STATE PROJECT NOS. 026-03-0042 and 026-04-0029
FEDERAL AID PROJECT NO. 1508(500)
US 65 – FOULES (NORTHBOUND)
ROUTE US 425
CONCORDIA and CATAHOULA PARISHES

SUBJECT: ADDENDUM NO. 1 (CONSTRUCTION PROPOSAL REVISION)
ELECTRONIC BIDDING AMENDMENT NO. 1

SHEET NUMBER 1		PROJECT 026-03-0042 (LEAD)		DATE		BY		REVISION DESCRIPTION		NO.		DATE		TITLE SHEET		CATAHOULA PARISHES		CONCORDIA & 026-04-0029		DISTRICT 58 DESIGN	
PARISH CONCORDIA		FEDERAL PROJECT 1508(500)		CHECKED		CHECKED		CHECKED		CHECKED		CHECKED		CHECKED		CHECKED		CHECKED		CHECKED

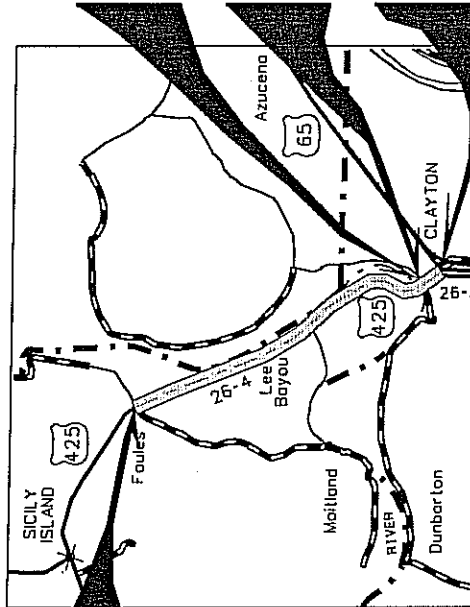
DATE	REVISION	DATE	RECOMMENDED	DATE	APPROVED
7-6-09	17-18e	7-8-09	18e	7-13-09	10e
